REVISION	DATE	REVISED DETAIL #1	RT
11/25/92			SY
NORMAN ENGINEERING CO.		DEPARTMENT OF THE ARMY	
CONSULTING ENGINEERS		SACRAMENTO DISTRICT, CORPS OF ENGINEERS	
LOS ANGELES, CALIFORNIA		SACRAMENTO, CALIFORNIA	
DESIGNED BY	MCCLELLAN AIR FORCE BASE CALIFORNIA		
R. SHEPARD	ADAL DEPOT CORROSION CONTROL FACILITY		
DRAWN BY	NEW AIRCRAFT PAINT FACILITY		
R. TAGAYUN			
CHECKED BY	GROUNDING PLAN B/B		
L. MYERS			
SUBMITTED BY	DATE APPROVED	SCALE: 1/16" = 1'-0"	SPEC No. 8529
9/30/92			
SHEET E-5		FILE No.	100-25-2051
77 OF 95

COLLINS ELECTRICAL CO., INC. 4107 Northgate Blvd. Sacramento, CA 95831 Phone: (916) 557-1100		DESIGNED BY R. SHEPARD		DRAWN BY R. TAGAYUN		CHECKED BY L. MYERS		SUBMITTED BY [Signature]	
DATE 9/30/92		DESCRIPTION NEW AIRCRAFT PAINT FACILITY		PROJECT ADAL DEPOT CORROSION CONTROL FACILITY		SHEET NO. E-8		TOTAL SHEETS 2051	
NORMAN ENGINEERING CO. CONSULTING ENGINEERS LOS ANGELES, CALIFORNIA				DEPARTMENT OF THE ARMY SACRAMENTO DISTRICT CORP. OF ENGINEERS SACRAMENTO, CALIFORNIA

GROUNDING PLAN

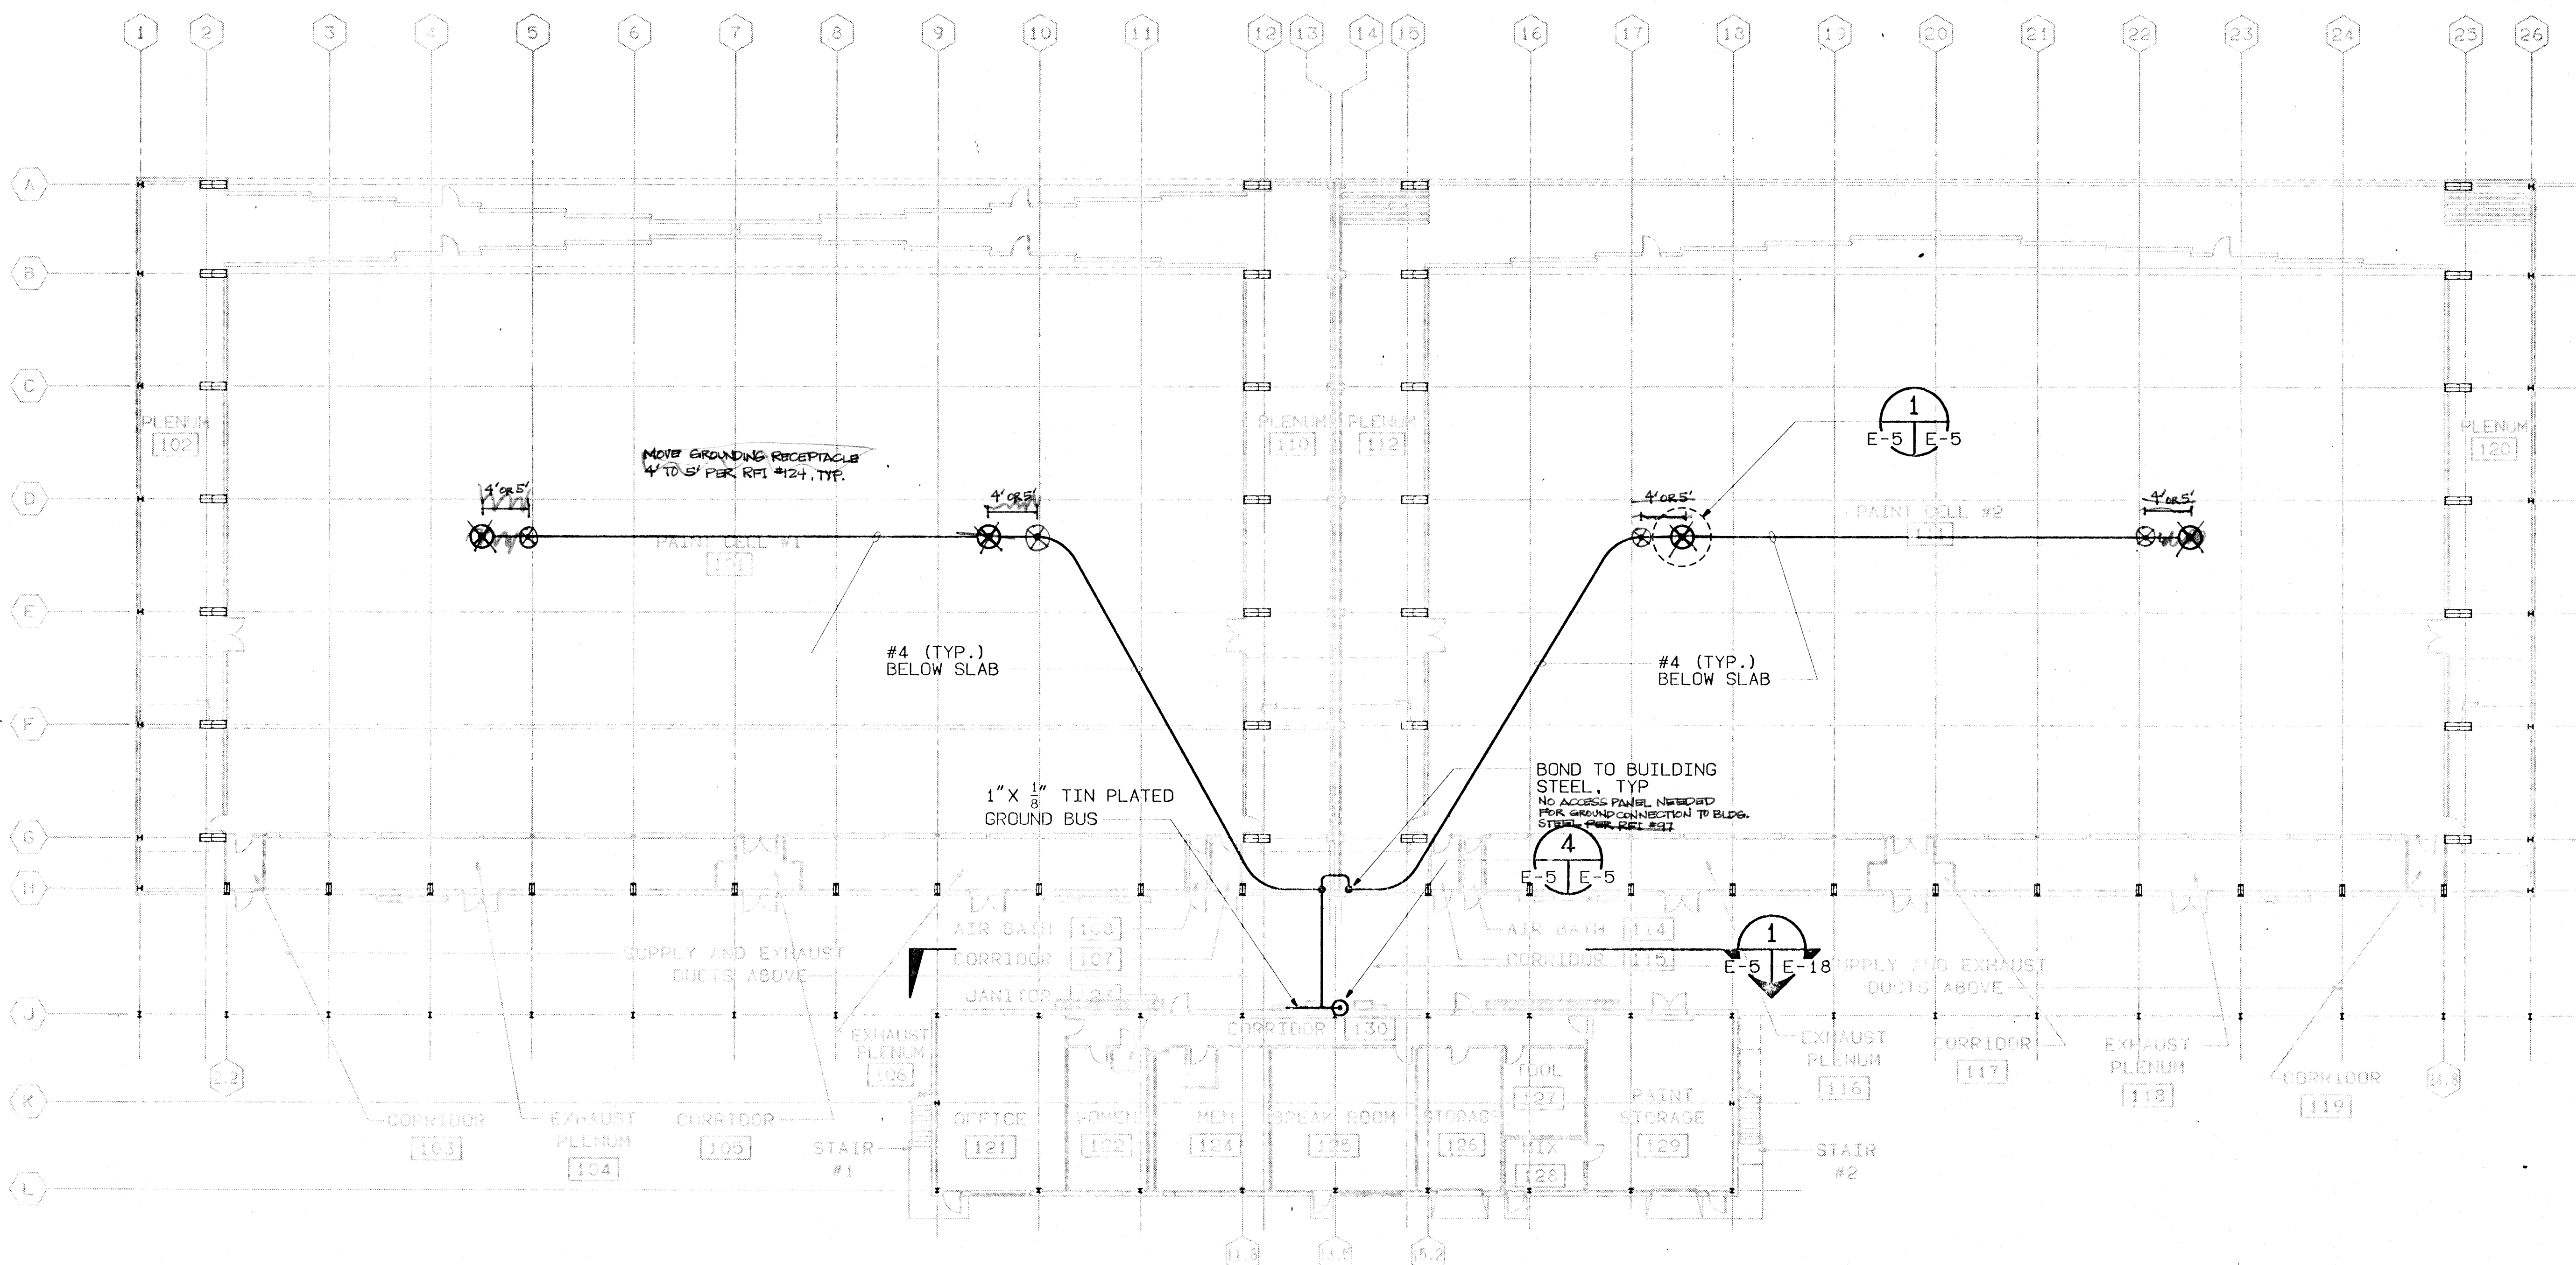
Reference your RFI-149, dated September 28, 1994, regarding ground bus at service building.

Specification Section 16415, Paragraph 3.1.3, states in part "...noncurrent-carrying metal parts of electrical equipment shall be effectively grounded by bonding to the bus. The ground rod or rods..."

Therefore all the electrical equipment enclosures in this electrical equipment area shall be bonded to the ground bus. Some of the electrical equipment in this area are MCC1, MCC2, DPL, LPL, RPL, PP2, 2H, Emergency Battery Unit, etc. Additionally, bonding of the neutral point of the secondary side of Transformer T1 to the grounding electrode conductor is acceptable, provided the ground rod. Also, please note that other connections to this ground bus are shown on the contract drawings.

LIGHTING PLAN - SOUTH

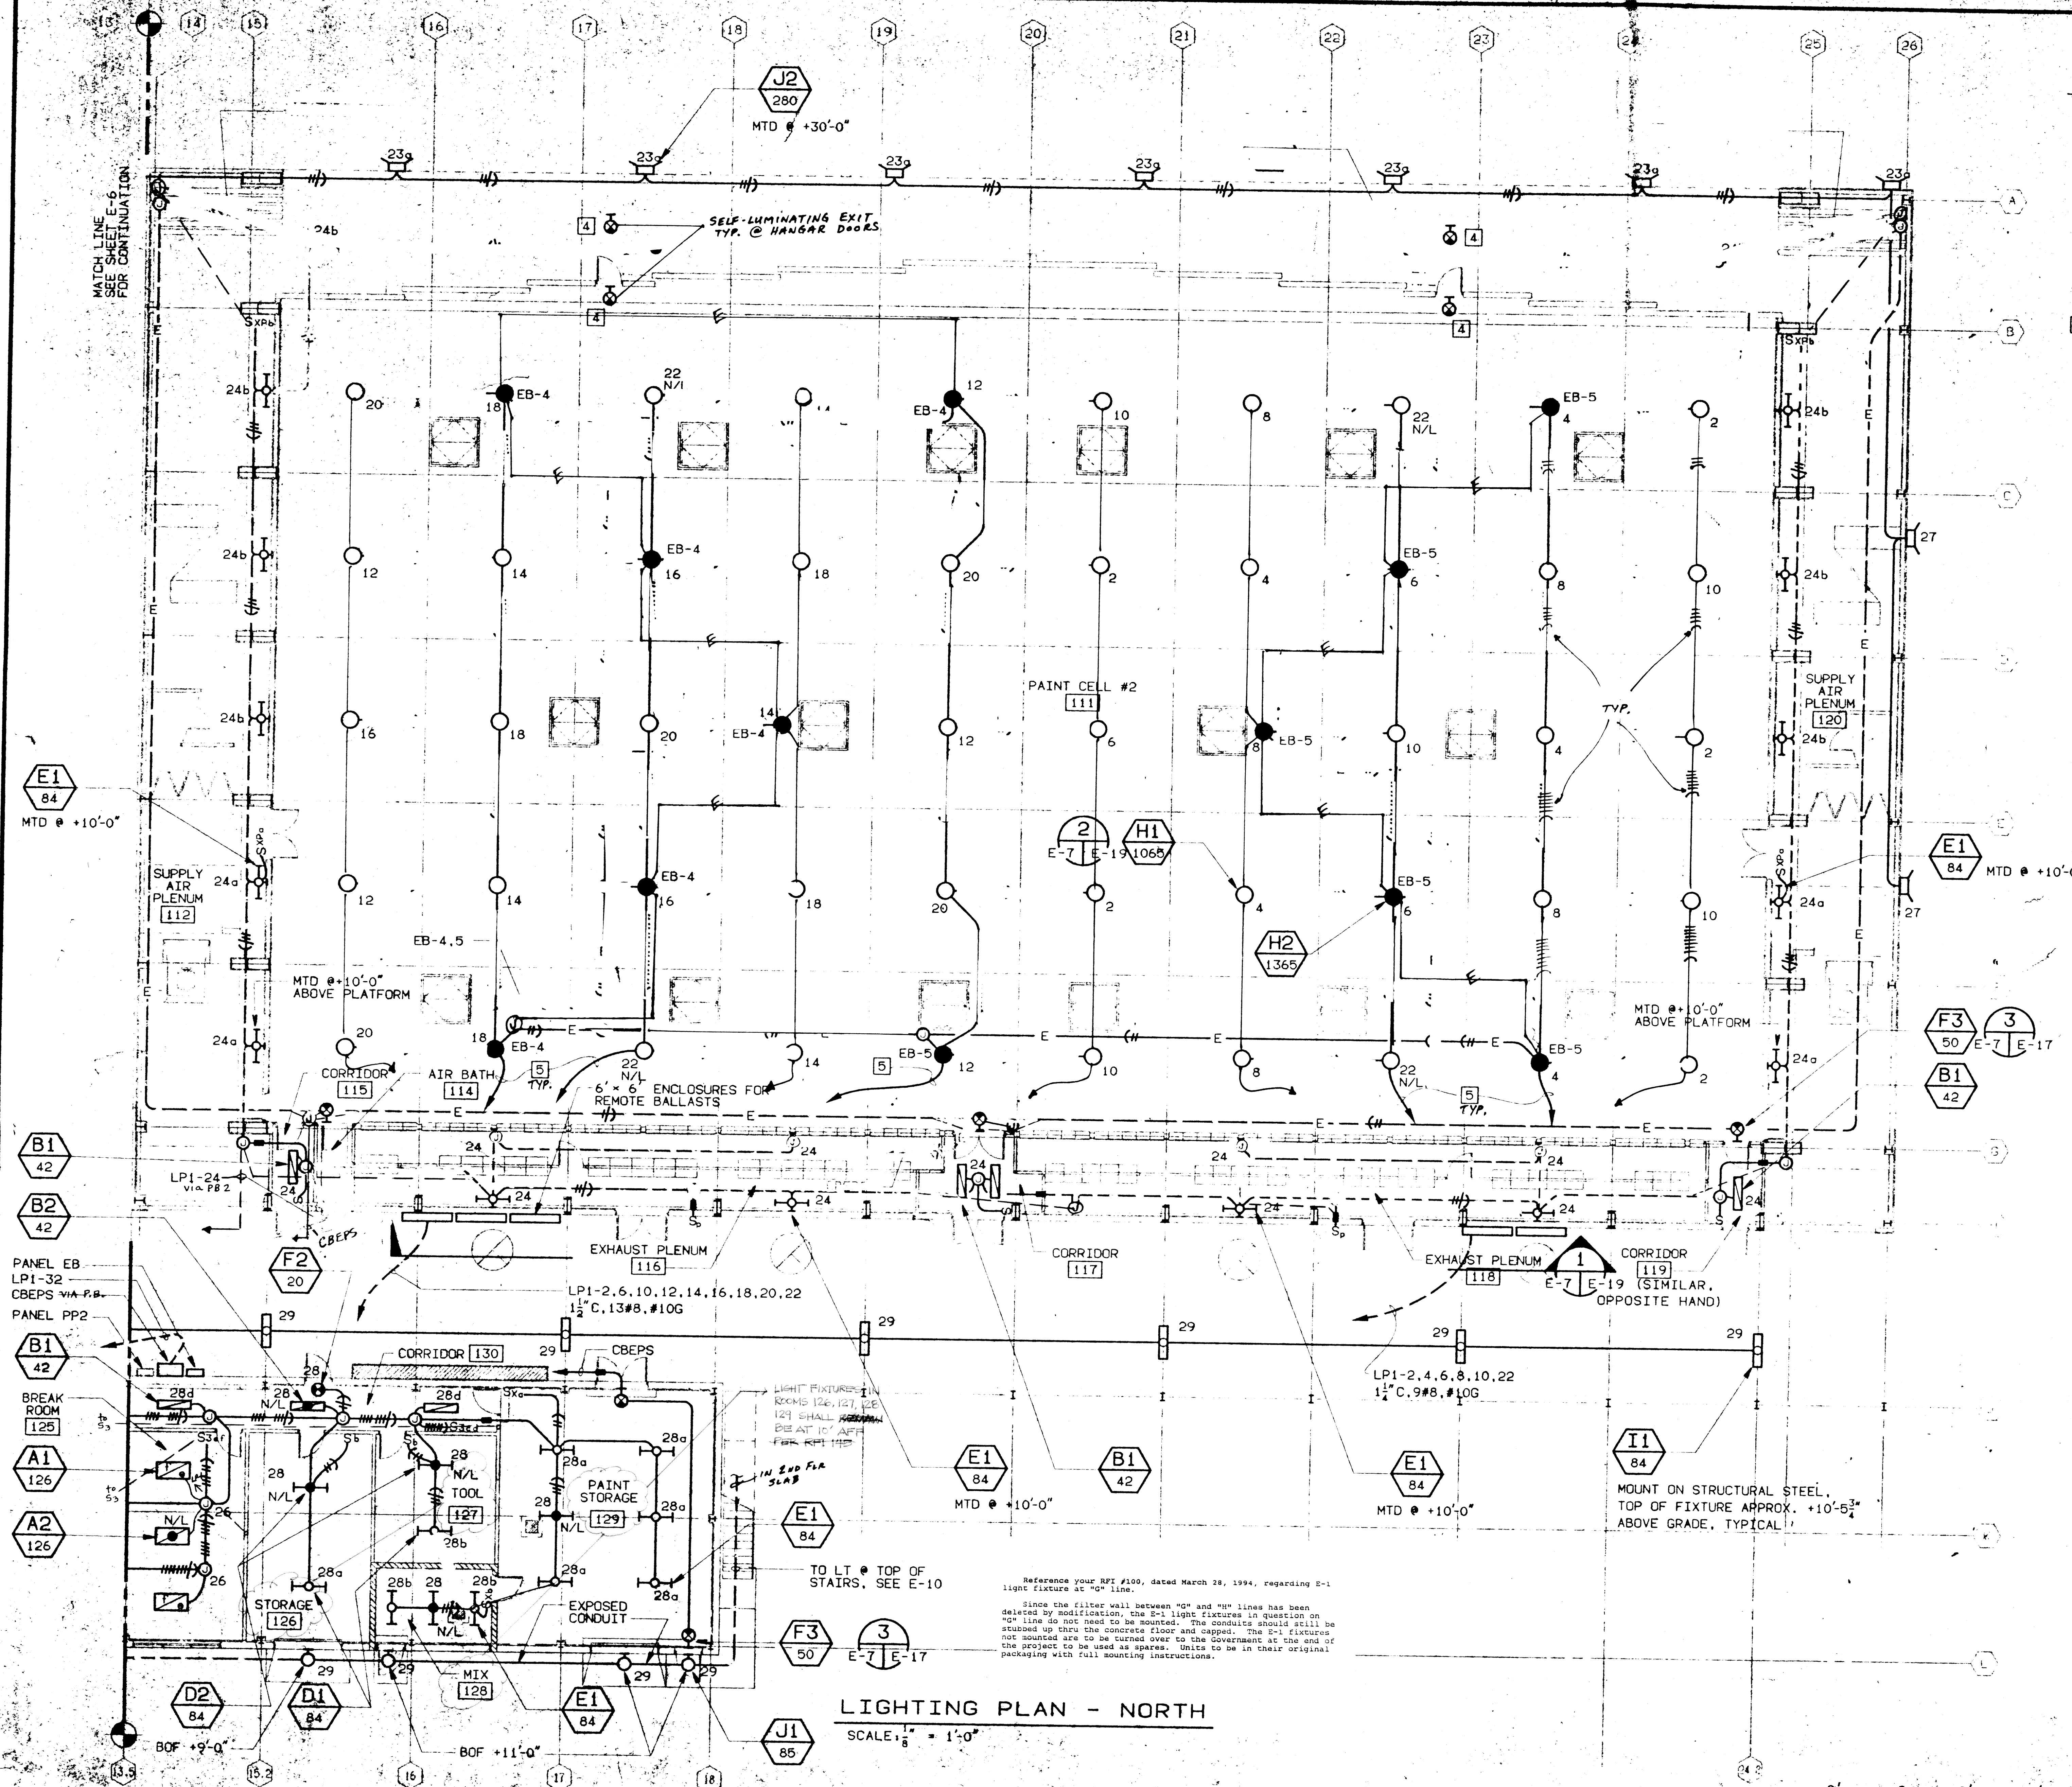
SEE RFI #23, RFP 13, R0012
 [5] LTG. H.R. VIA GUTTER ON BLDG. EXT.
 TO BALLAST CAB.
 3/4" C. 10#12, #12 GND.
 SEE 5/819 PER RFI'S 75#103, RFP 44, R0033

Reference your RFI #72, dated January 19, 1994, regarding the branch circuit conductors running underground in the Class Division 1 hazardous area, as defined by the contract drawing sheet E-2. A review of your attached drawing produced the following comments:

Circuits 23, 25, 27, & 29 should be controlled via a time switch as noted in the panel schedule on sheet E-15. The lighting contactor and time switch is located adjacent to Panel LP1, shown on Sheet E-16. Provide 24 hr time switch with override switch. Provide power to time switch from Panel LP1, SEE E-24

LIGHT FIXTURE L1 IS NOT CONNECTED TO THE EMERGENCY LIGHTING CIRCUIT PER RFI #31

- The seal-off located at the conduit stub-up shall be relocated to immediately outside the classified boundary. The seal-off can be located at the adapter between the rigid steel and rigid non-metallic conduit, but there shall be no fittings between the boundary and the seal-off. Reference NEC article 501-5(a)(1).
- All conduit seal-offs shall remain accessible. Reference NEC article 501-5(c)(1).
- Seal-offs will be required within 18 inches of each electrical device that is not factory sealed. Reference NEC article 501-5(a)(1).
- Steel conduit in contact with earth shall be protected against corrosion. Reference specification section 1415 paragraph 3.2.2.1.
- Conduit installed within the slab on grade shall comply with specification section 1415 paragraph 3.2.2.2.
- Conduit crossing a structural joint shall be installed to comply with section 1415 paragraph 3.2.2.
